PRODUCT BULLETIN # 16817

Issue Date: 02-Apr-2012

TITLE: Packaging Changes Affecting Sanyo Thailand Impacted Products

Graphical Shipping Package Variations for Future Shipments

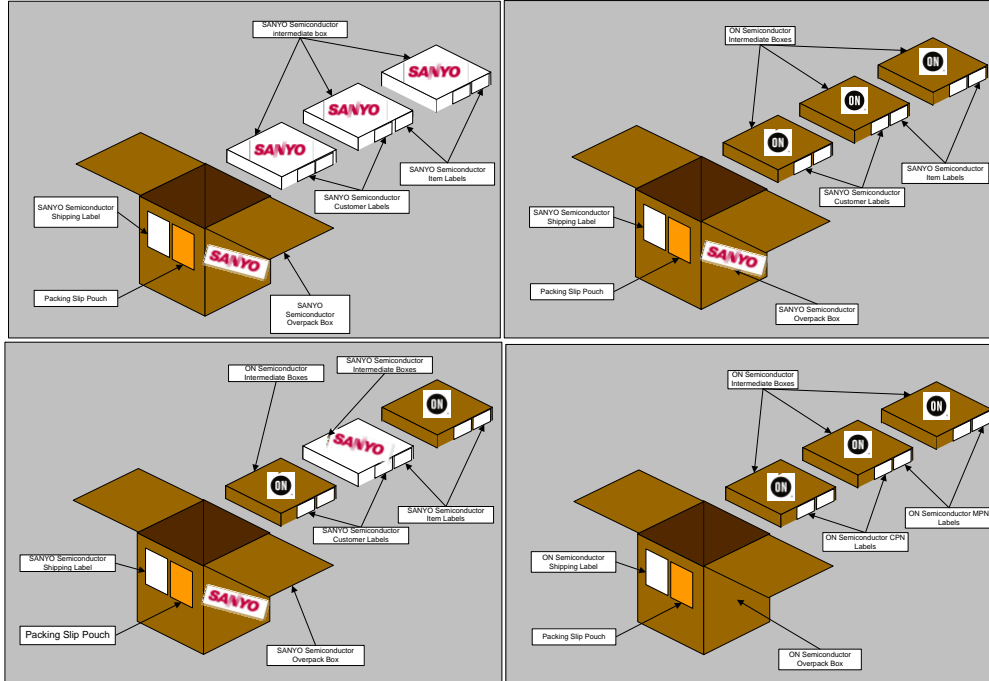
The severe floods in Thailand have caused ON Semiconductor to perform manufacturing transfers in order to support pre-flood production. Please note the Shipping Package guidelines and changes indicated by assembly package group. The changes are only for products affected by SSTH recovery and are not for all ON Semiconductor or SANYO Semiconductor products.
